The Commission has issued the enclosed Amendment No. 16 to Facility Operating License No. NPF-16 for the St. Lucie Plant, Unit No. 2. This amendment consists of changes to the Technical Specifications in response to your application dated July 15, 1986 as supplemented by two letters dated September 4, 1986 and one letter dated October 10, 1986.

This amendment changes the Reactor Coolant System Pressure/Temperature (P/T) limit figures to be effective up to four effective full power years of operation. The amendment changes the technical specifications dealing with overpressure protection systems because they are linked with the new P/T limit figures. The amendment also adds the shutdown cooling system relief valves as overpressure protection devices. The applicable bases sections are changed to reflect the above changes.

AMENDMENT TO FACILITY OPERATING LICENSE

Amendment No. 16  
License No. NPF-16

**FIGURE 3.4-2  
ST. LUCIE-2 P/T LIMITS, 4 EPY  
HEATUP AND CORE CRITICAL**

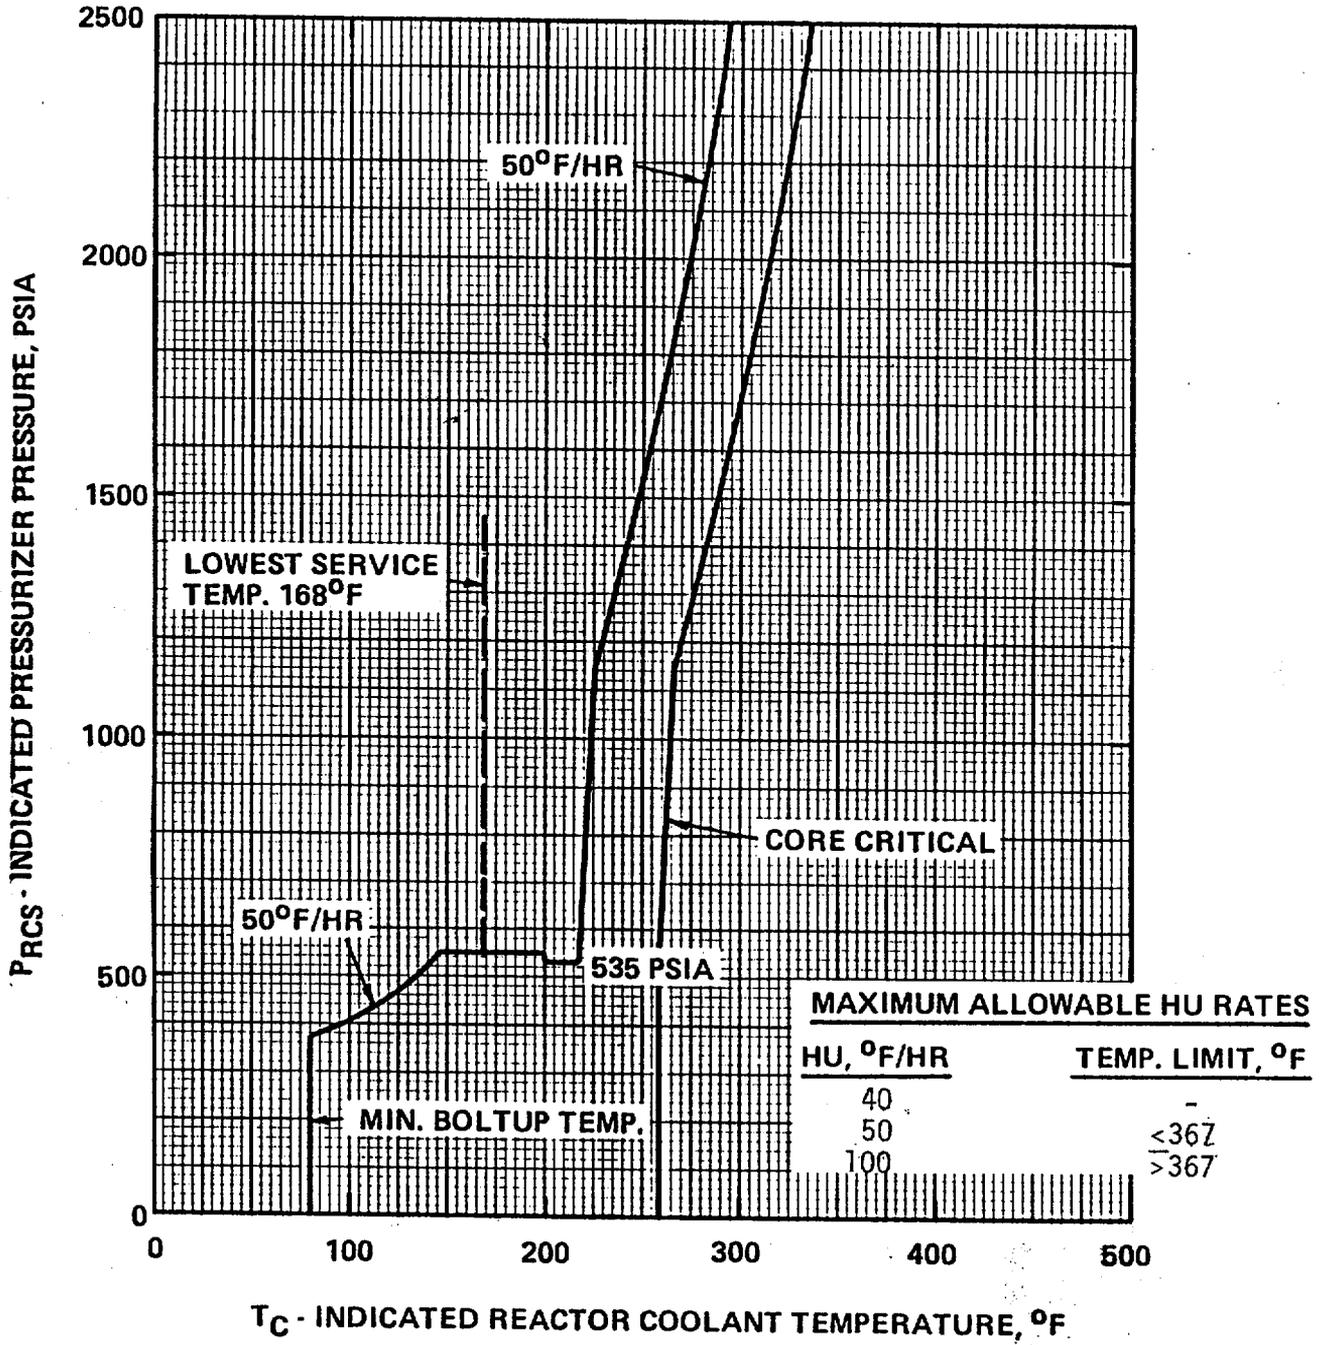
The licensee indicated that the P/T limits currently specified in Figure 3.4-3 of the TS will expire in October 1986. A set of new P/T curves (new Figures 3.4-2 and 3.4-3) was submitted for staff review and approval. The licensee also proposed to modify the LTOP system to use (1) shutdown cooling system (SDCS) relief valves (RVs) for LTOP during heatup when any reactor coolant system (RCS) cold leg temperature is less than 142°F and cooldown when any RCS cold leg temperature is less than

The cooldown curve for 100°F/hr computed by the licensee conservatively bounds the pressure-temperature curve computed by the staff for the same cooldown rate. Pressure-temperature curves in Figure 3.4-3 for cooldown rates of 0°F/hr (isothermal), 30°F/hr, 50°F/hr and 100°F/hr are acceptable to the staff. The heat-up curve for 50°F/hr computed by the licensee does not bound the pressure-temperature curve computed by the staff for the same heat-up rate. The temperature values differ by as much as 5% at 1400 psig. The difference in computed temperature values between the licensee and the staff are due to (1) the methodology used to attenuate the neutron fluence through the vessel wall and (2) the methodology used to determine the temperature gradient through the vessel wall. A difference in calculated temperature of 5% is not acceptable to the staff. When the entire methodology of Draft Regulatory Guide 1.99, Revision 2, is employed (including the expression for fluence attenuation through the vessel wall), the pressure-temperature curve in Figure 3.4-2 for a heat-up rate of 50°F/hr corresponds more closely to an inner surface neutron fluence of  $0.725 \times 10^{19}$  n/cm<sup>2</sup> (E>1MeV). A neutron fluence of  $0.725 \times 10^{19}$  n/cm<sup>2</sup> (E>1MeV) corresponds to 4 EFPY. Thus, the curves in Figures 3.4-2 and 3.4-3 drawn for 5 EFPY are acceptable to the staff for only 4 EFPY. Pressure-temperature limits for heat-up and cooldown during core operations are obtained by adding 40°F to the temperature values in Figures 3.4-2 and 3.4-3. The resulting temperature must be greater than or equal to the minimum critically temperature, 253°F.

Based on the above evaluation, the staff concludes that the licensee's proposed changes to TS Sections 1.16, 3.4.1.3, 3.4.1.4.1, 3.4.9.1, 4.4.9.1.2, Figure 3.4-2, Figure 3.4-3, 3.4.9.3, 3.5.3, Bases 3/4.4.1 Bases 3/4.4.9, and Bases 3/4.5.3 as submitted in its letter dated October 10, 1986 are acceptable. Acceptance is based in part on the licensee's commitment to submit confirmatory analyses for the staff's review and approval prior to January 15, 1987. Lastly, the staff recommends the Technical Specifications be changed to reflect the scheduled withdrawal of five surveillance capsules, one each at 1.5, 3, 6, 15 and 32 (EOL) effective full power years. By letter dated September 4, 1986,

**FIGURE 3.4-3**  
**ST. LUCIE-2 P/T LIMITS, 4 EPY**  
**COOLDOWN AND INSERVICE TEST**

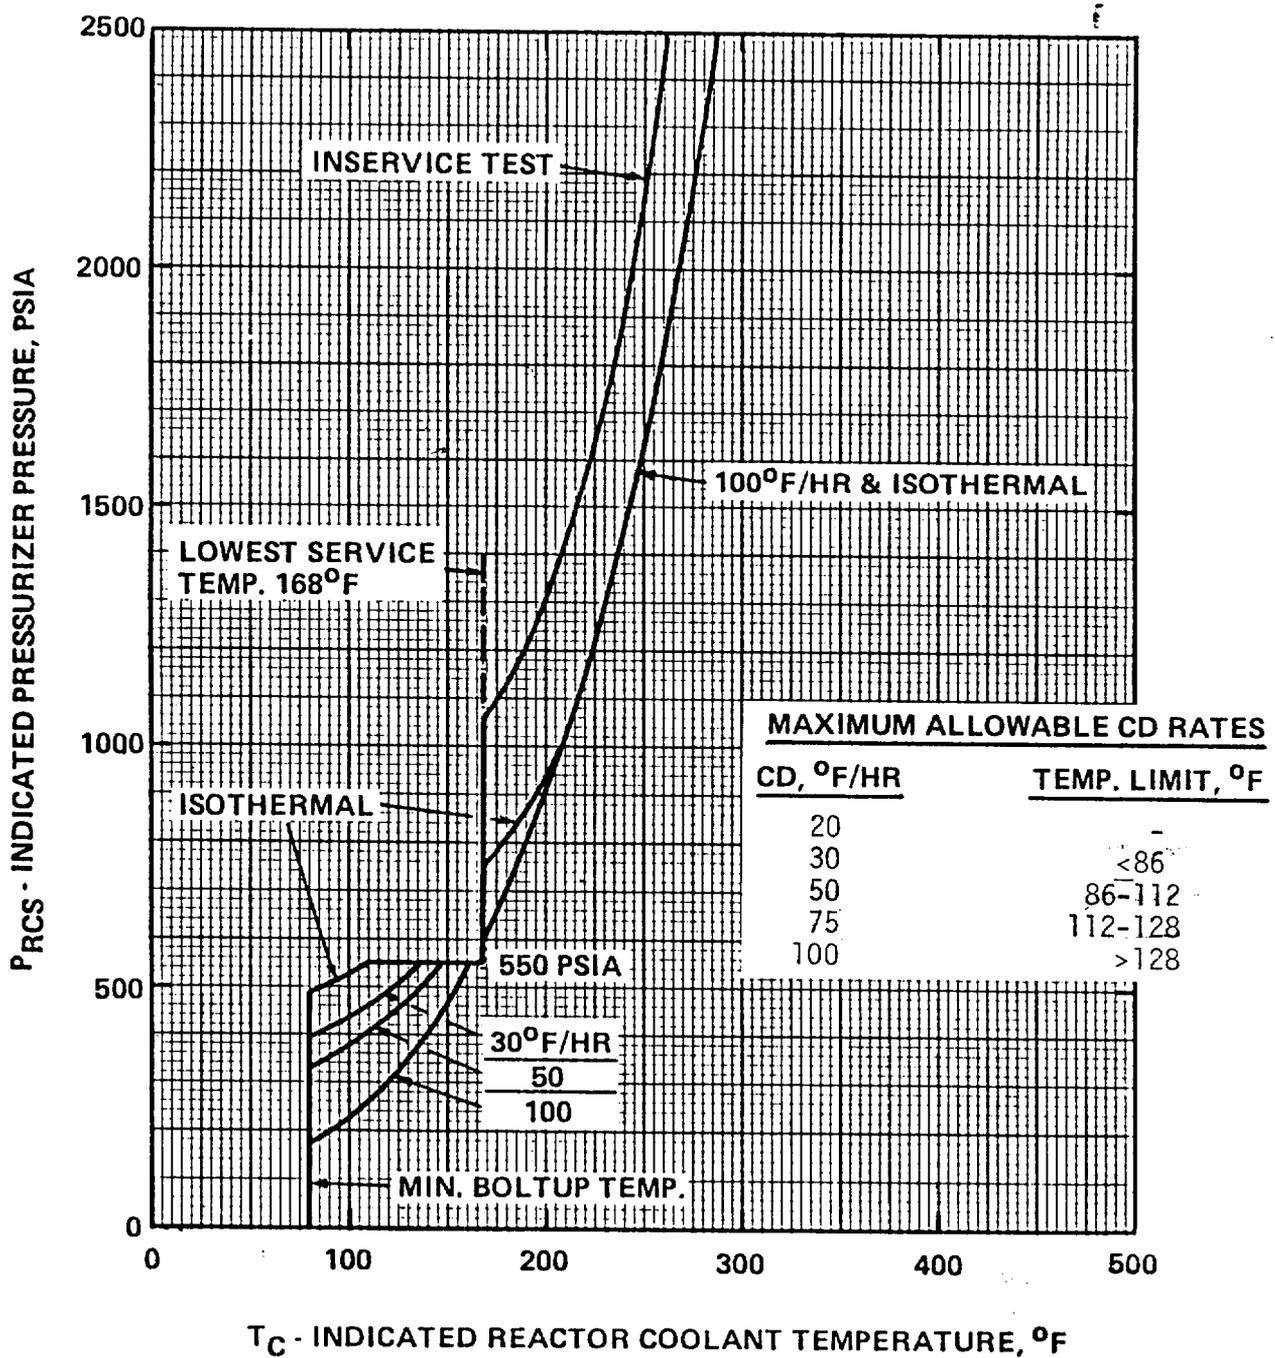
St. Lucie, Unit 2 presently uses power operated relief valves (PORVs) for overpressure protection during low temperature operating conditions. Pressure/temperature (P/T) limits for plant cooldown and heatup are specified in Figure 3.4-3 of the technical specifications (TS). The licensee's analyses of record assume an inadvertent actuation of a safety injection signal which results in the startup of one high pressure safety injection (HPSI) pump and three charging pumps for a postulated mass addition transient. The analyses assume a maximum secondary to primary temperature differential of 100°F for a postulated inadvertent reactor coolant pump (RCP) start event. The results of these analyses support plant operation in the temperature range within which the Low Temperature Overpressure Protection (LTOP) system is required.
